DEVIATION REQUEST (Attach diagrams, figures, and other documentation to clarify request)

A deviation from the standards of or in Section **ECM 4.3.6.3** of the Engineering Criteria Manual (ECM) is requested.

THE GLEN AT WIDEFIELD FILING NO 11
Shallow Cover Storm Sewer (at Box Culvert)

Kiowa Project No. 19016
October 5, 2021

POA ANNUA INTERSECTION DETAIL

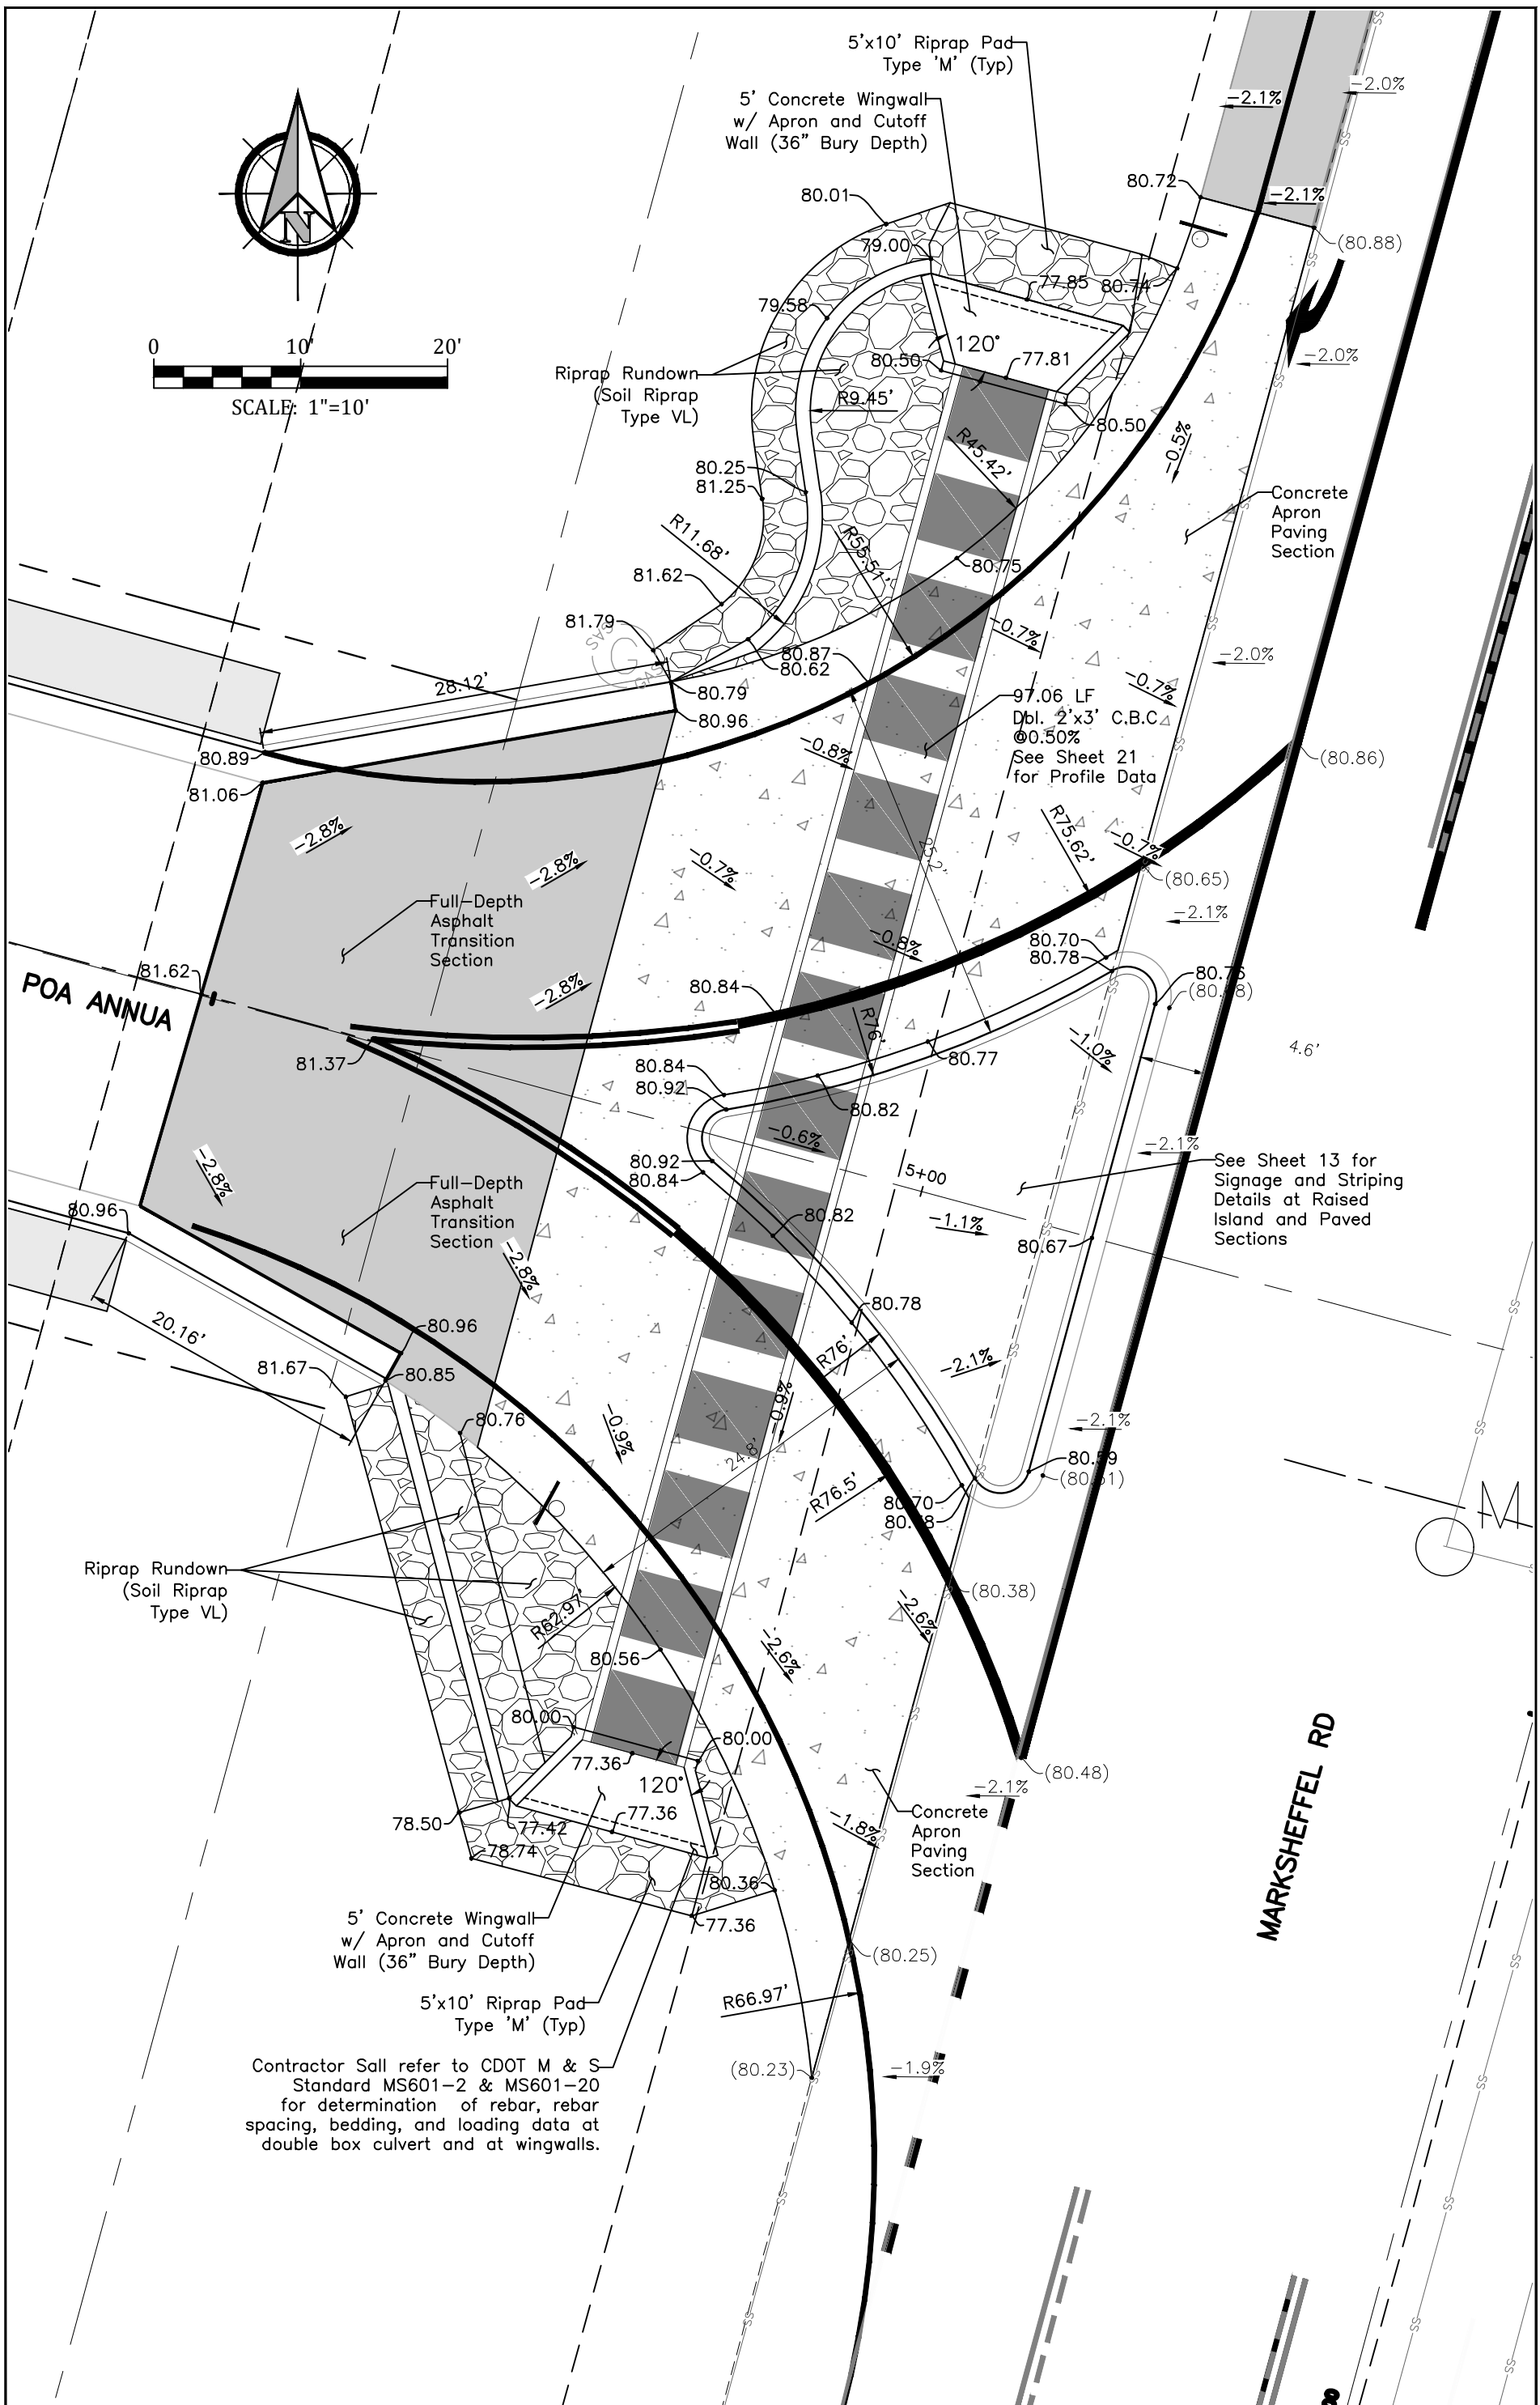
Proposing A Full-depth (6") Concrete Apron/Driving Surface atop a Box Culvert at planned Poa Annua intersection.

There will be no soil cover (0'-0") at this location. 2' of cover is required by criteria. The box culvert lid will be designed to specification AASHTO HL-93 at the time of construction/installation by a structural engineer.

See Attached Exhibit 'C' for Plan and Profile of Box Culvert and for the limits of the planned concrete apron.

The box culvert top section will be designed to HL-93 Specification which exceeds HS-20 loading levels.
 A certification letter from the structural engineer will be provided to El Paso County prior to construction of the box culvert.
